Upper Browns Bar HSR Model Study Read-Ahead

Upper Brown's HSR Model Study Final Meeting
8/28/14 at 9am

PLATE
NUMBER
8

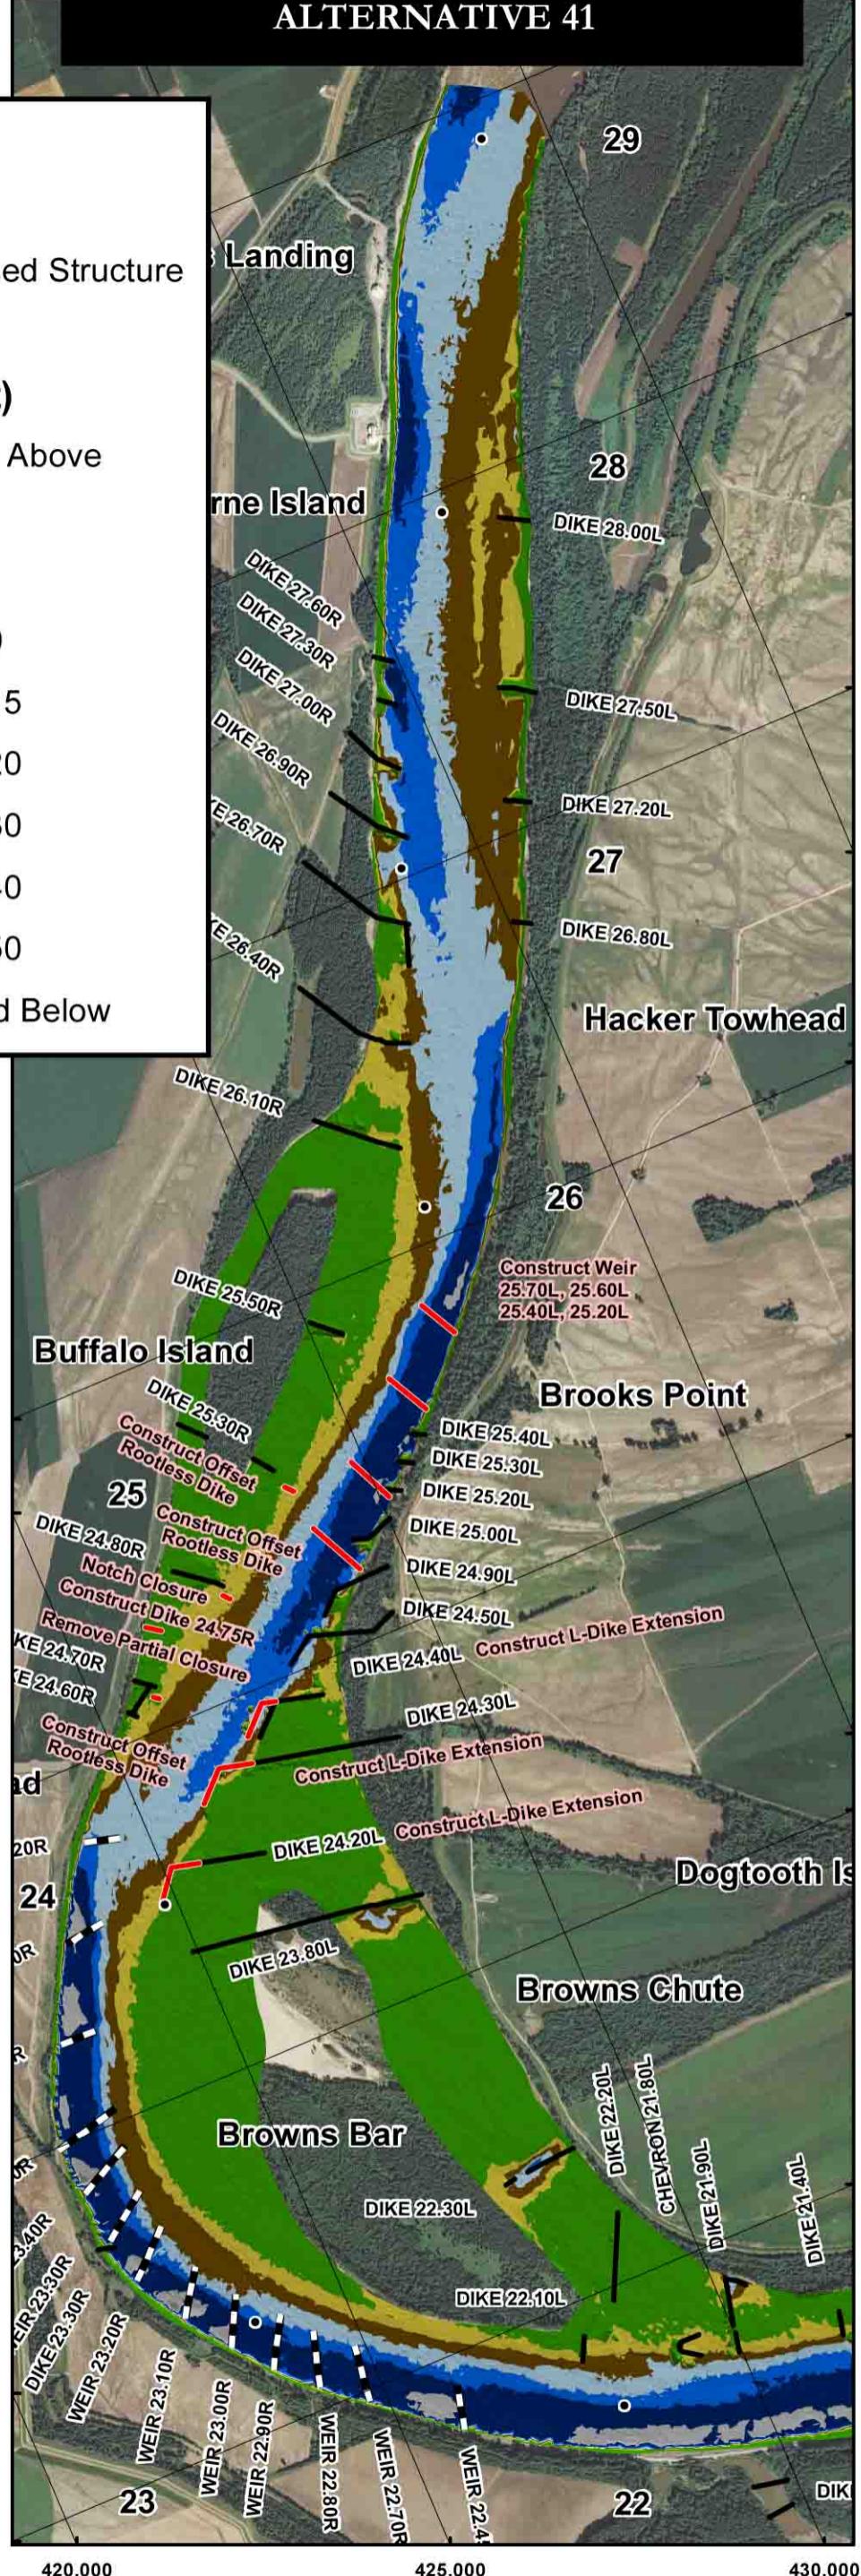
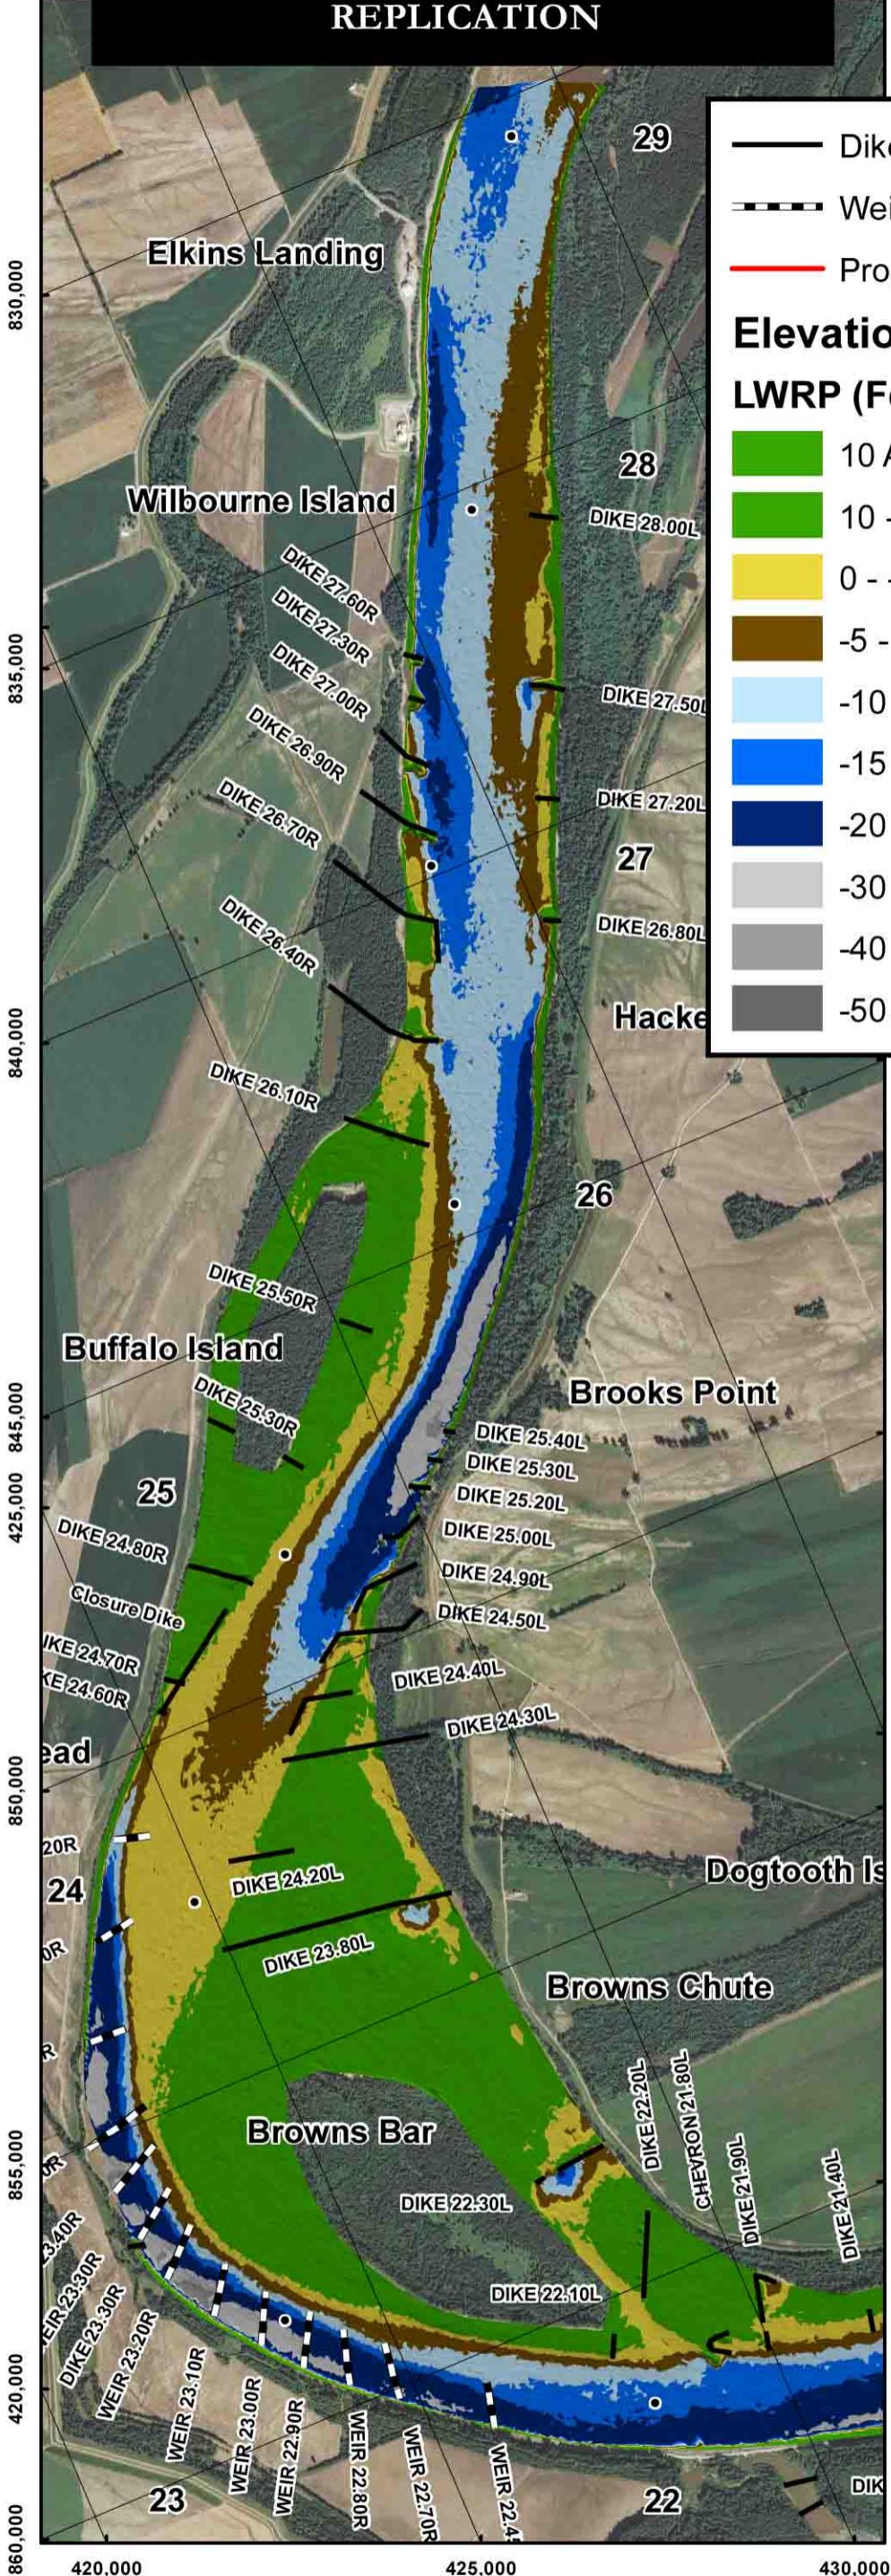
-First comment by navigation was regarding proposed Dike 24.25R. It's located in an existing "waiting location", so Ivan will remove it from Alternative 39 and test it as Alternative 41.

Path Forward: Do two additional tests – Alternative 41 = Alternative 39 minus Dike 24.25R

PLATE
NUMBER
18

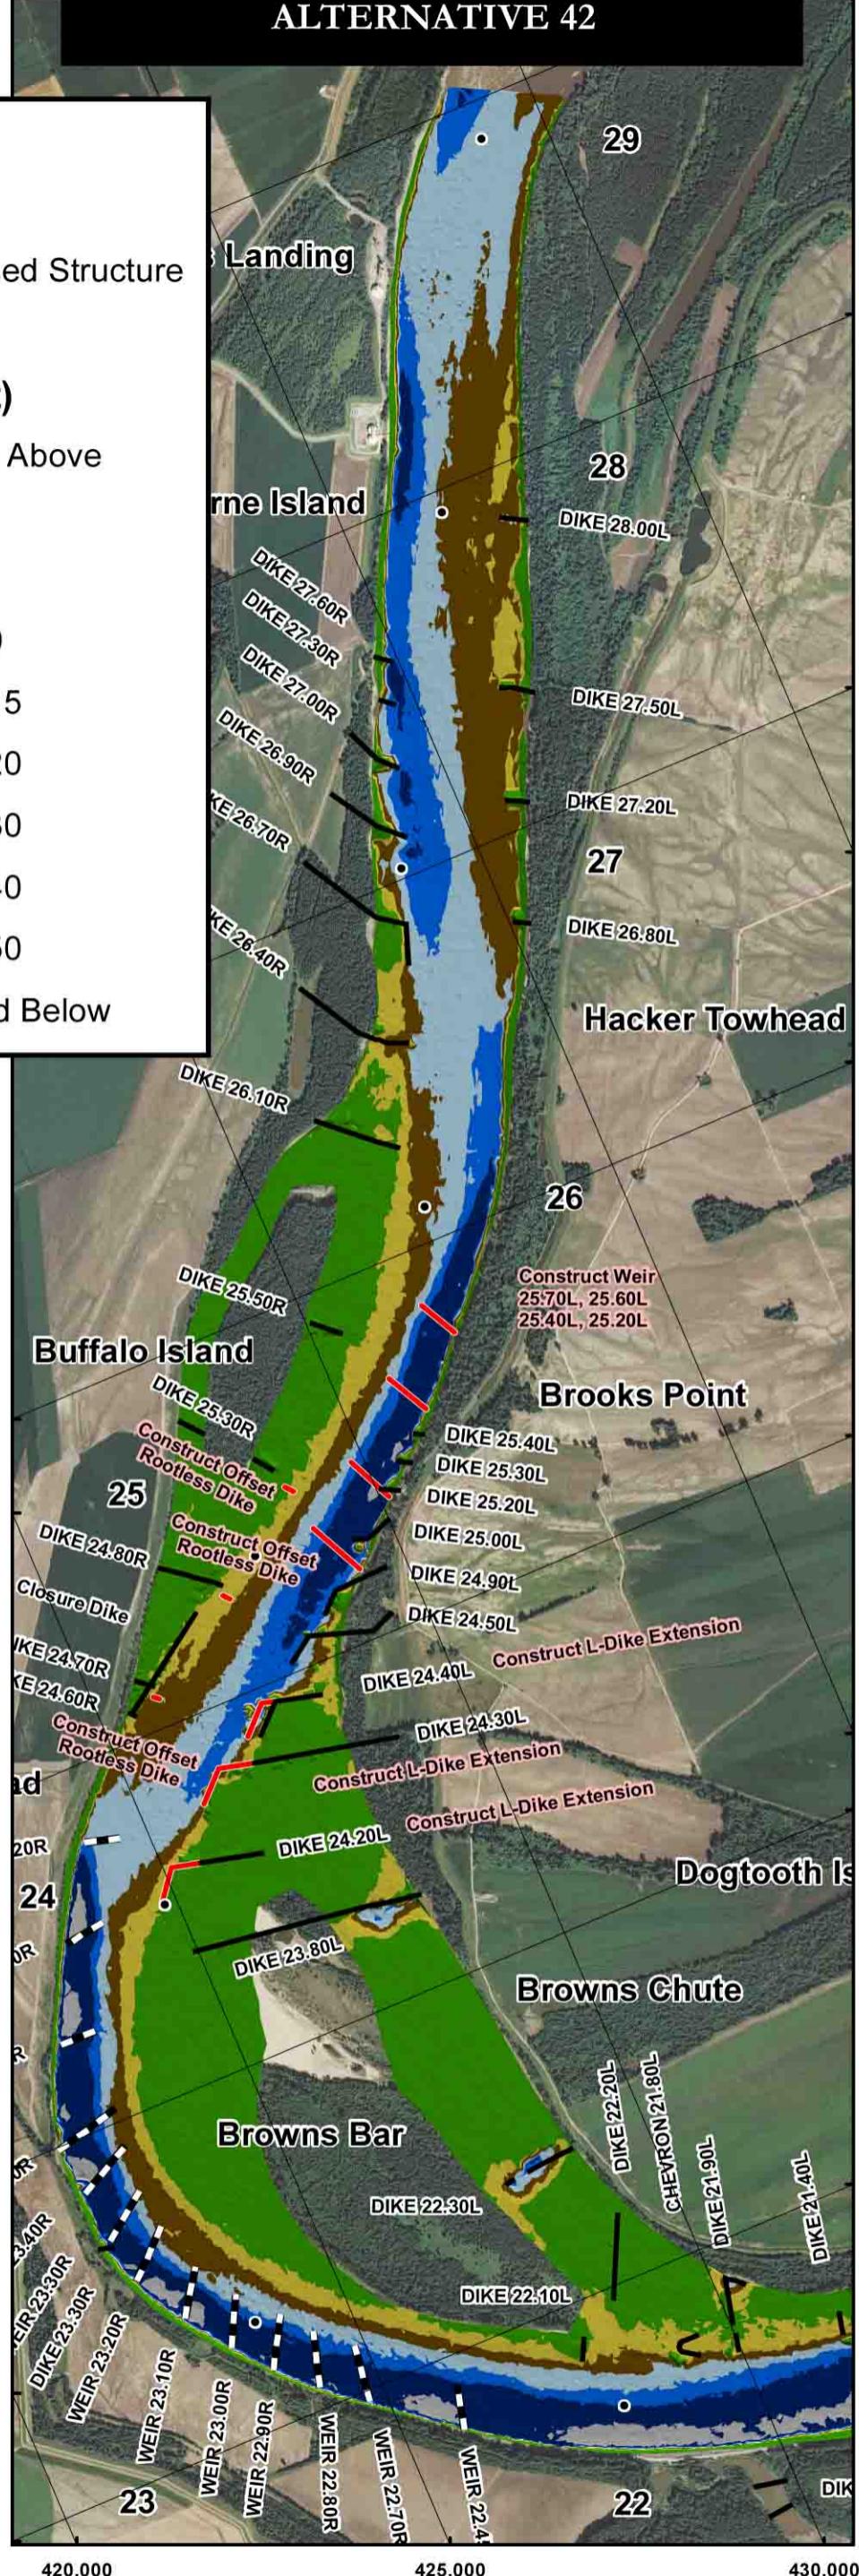
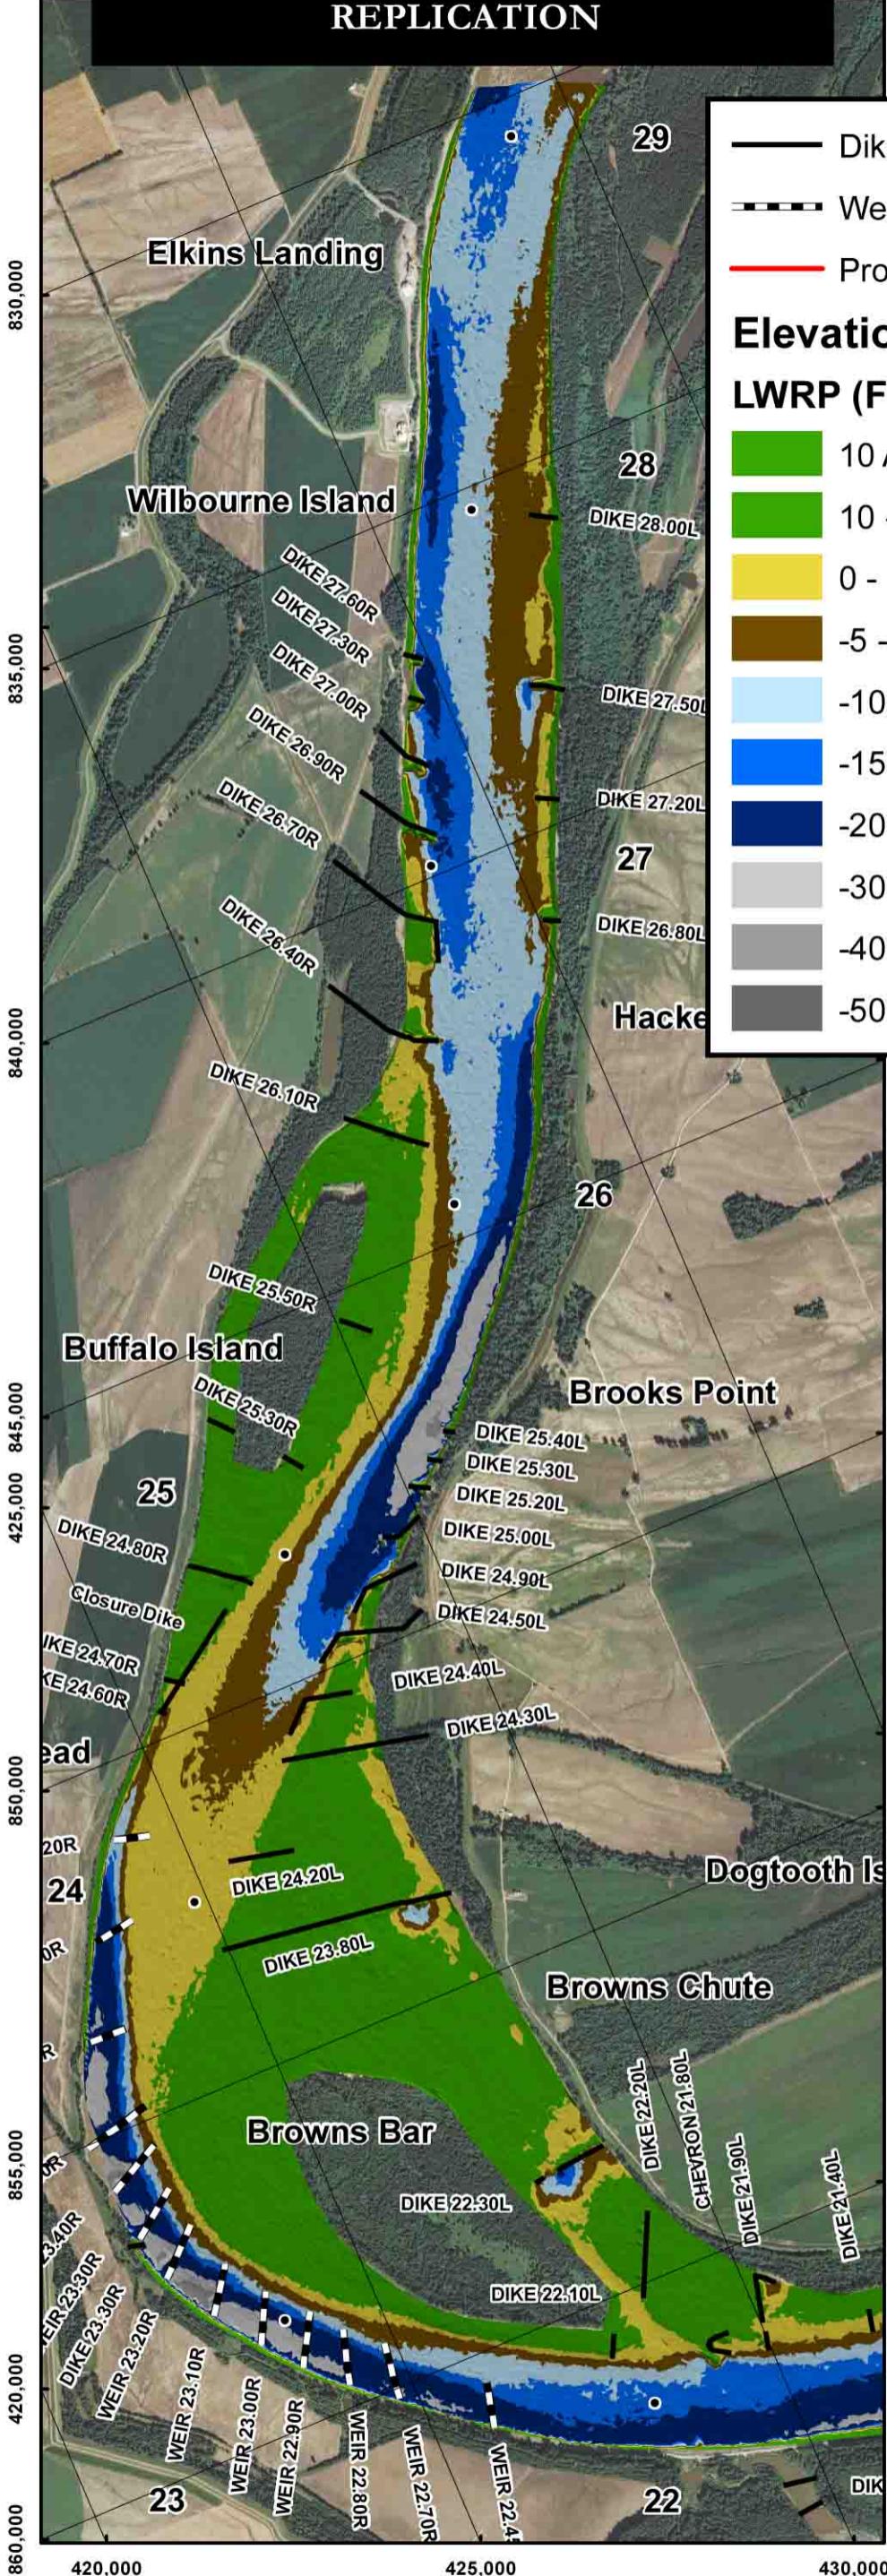
Alternative 42 = Alternative 41 minus the Buffalo Chute work (to see if the structures improve the navigation channel/alignment)

Alternative 42 was recommended as the most desirable alternative because of its potential to eliminate the need for repetitive dredging between RM 25.00 - 23.50 while maintaining flow through Upper Brown's Chute.

After the additional tests (Alternatives 41-44) were completed, the plates/results were sent out to the group via email. Alternative 42 was recommended, and some representatives from partnering agencies responded with some comments. On the RRAT trip further discussion needs to occur to clarify any confusion and help us choose a path forward for this reach.
